Amendments to the Drawings

The attached sheets of drawings include changes to Figure 1, Figure 4, and Figure 5. These sheets replace the original sheets including Figure 1, Figure 4, and Figure 5.

FIGURE 4

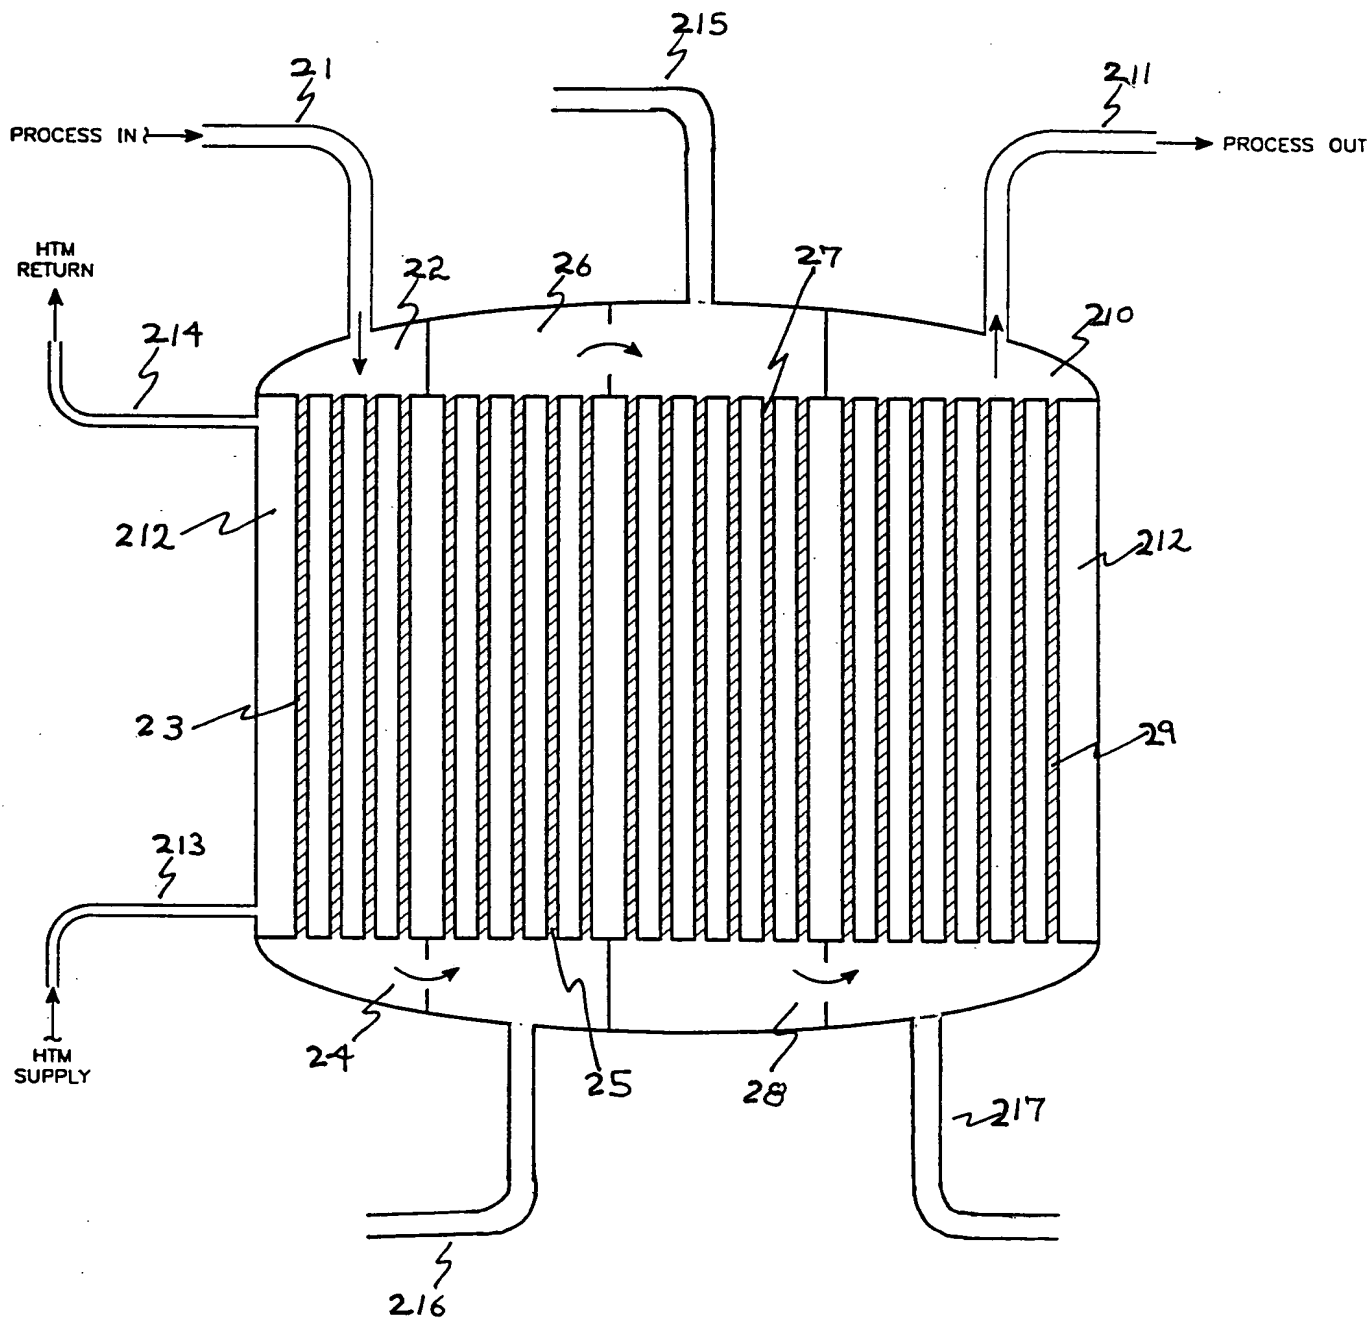
In Figures 4 and 5, the reference character numbers in the drawings have been changed by placing the number "2" prior to each reference character number so that reference character numbers 1, 2, 3, 4, 5, 6, 7, 8, 9, 10, 11, 12, 13, 14, 15, 16, and 17 now read as 21, 22, 23, 24, 25, 26, 27, 28, 29, 210, 211, 212, 213, 214, 215, 216, and 217. This change was made to clarify that the reference characters of Figures 4 and 5 differ from those of Figure 2. Annotated copies of Figures 4 and 5 are included, which show the changes in red.

In the Drawings, Figure 1 has been amended to add the notation "Prior Art" as requested by the Examiner. Figures 4 and 5 have been amended to place the number "2" prior to each reference character number to clarify that the reference characters of Figures 4 and 5 differ from those of Figure 2.
